UNITED STATES PATENT AND TRADEMARK OFFICE

Office Action Summary

10/065,772

Fig. 2

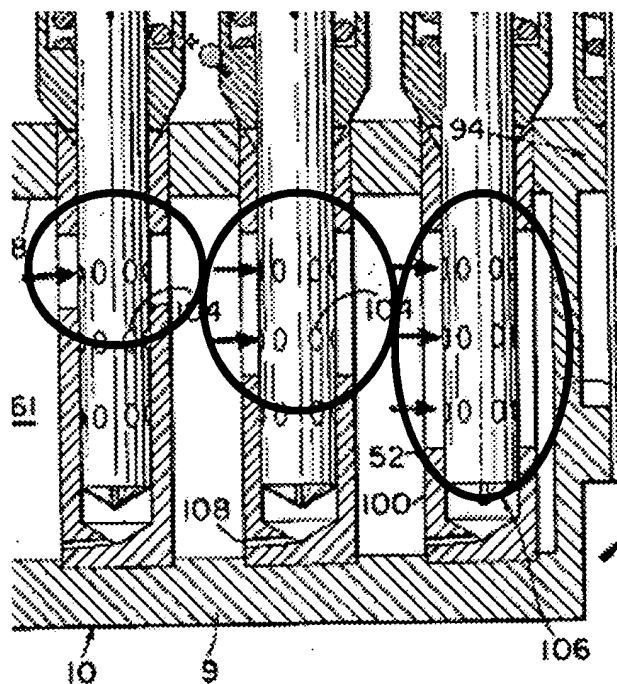
Further, Patterson Fig 2. clearly shows a means of controlling coolant flow separate from the means of controlling coolant flow for each individual main coolant flow channel as indicated by the circles imposed on said Figure 2 below.
